**Amendments to Code of Practice for  
Structural Use of Concrete 2013 (2020 Edition)**

**Amendments to the Code of Practice for Structural Use of Concrete 2013 (2020 Edition)**  
**( February 2022 )**

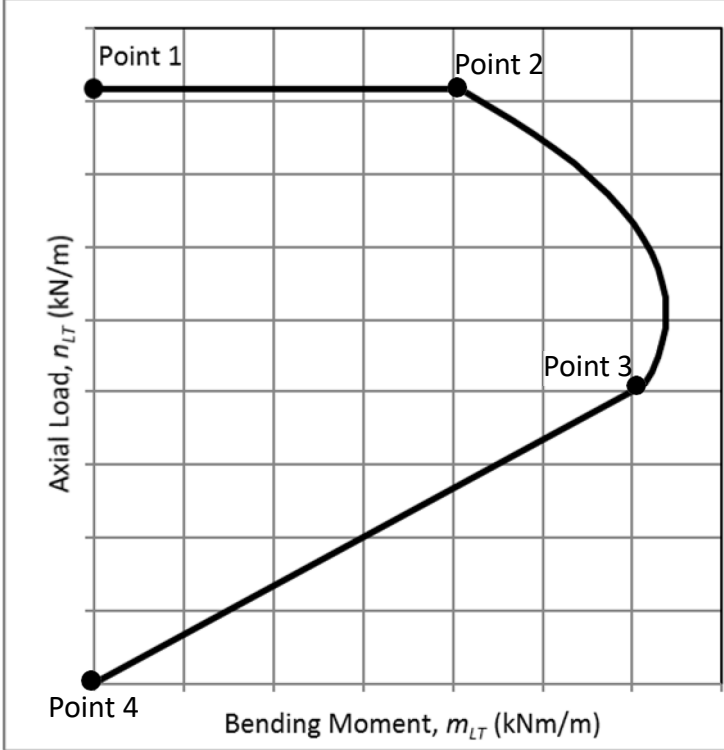
| Item                             | Current version  | Amendments  |
|----------------------------------|--|---|
| 4. Clause 6.2.3 and Figure 6.18b | -  | <b>6.2.3 Plain concrete linings</b><br><b>6.2.3.1 General</b><br>Plain concrete is suitable for use in structural members with high axial loads and relatively low bending moments. The following criteria can generally be applied to the use of plain concrete lining in tunnels or caverns:<br>(a) the lining curvature is adequate to accommodate axial distribution of external loads;<br>(b) the plain concrete lining is constructed in relatively good rock geology and is always in compression under all load combinations;<br>(c) the effect of imperfection of the concrete lining has been considered by means of rigorous structural analysis of the plain concrete lining; and |

| Item | Current version | Amendments  |
|------|-----------------|---|
|      |                 | <p>(d) an arch section can be formed by plain concrete in conjunction with a reinforced concrete invert provided the junction between the plain and reinforced concrete satisfies the design requirements specified in clause 6.2.3.2.</p> <p>6.2.3.2 <i>Design of plain concrete lining</i></p> <p>(a) Maximum axial load for plain concrete lining</p> <p>The design ultimate capacity of axial load per unit length, <math>n_{LT}</math> and design maximum ultimate bending moment per unit length, <math>m_{LT}</math> (<math>=n_{LT} e_x</math>) shall be evaluated using the interaction curve as shown in Figure 6.18b.</p> <p>(i) The first section (Point 1 to Point 2) of the interaction curve as shown in Figure 6.18b, the highest axial force, is applicable when the eccentricity of the thrust force is less than or equal to <math>0.1h</math>. The ultimate capacity is calculated using a rectangular stress block over the whole section;</p> <p>For <math>e_x \leq 0.1h</math></p> $n_{LT} \leq 0.32h f_{cu} \quad 6.63a$ <p>(ii) The second section (Point 2 to Point 3) of the interaction diagram is based on a rectangular stress block approach and is applicable for eccentricity between <math>0.1h</math> and <math>0.3h</math>. The stress block is acting over part of the section, and reduces as the eccentricity increases.</p> <p>For <math>0.1h &lt; e_x \leq 0.3h</math></p> $n_{LT} \leq 0.4 (h - 2 e_x) f_{cu} \quad 6.63b$ <p>where:</p> |

| Item | Current version | Amendments   |
|------|-----------------|--|
|      |                 | <p><math>e_x</math> is the resultant eccentricity of load at right angles to the plan of the lining.</p> <p>(iii) Cracking restriction limits the use of the strength design method to a maximum eccentricity of <math>0.3h</math>. The third section (Point 3 to Point 4) of the interaction curve is a straight line down to the point <math>n_{LT} = 0</math>, <math>m_{LT} = 0</math>, as shown in Figure 6.18b.</p>  <p><b>Figure 6.18b – Interaction Curve for Design of Plain Concrete Lining</b></p> |
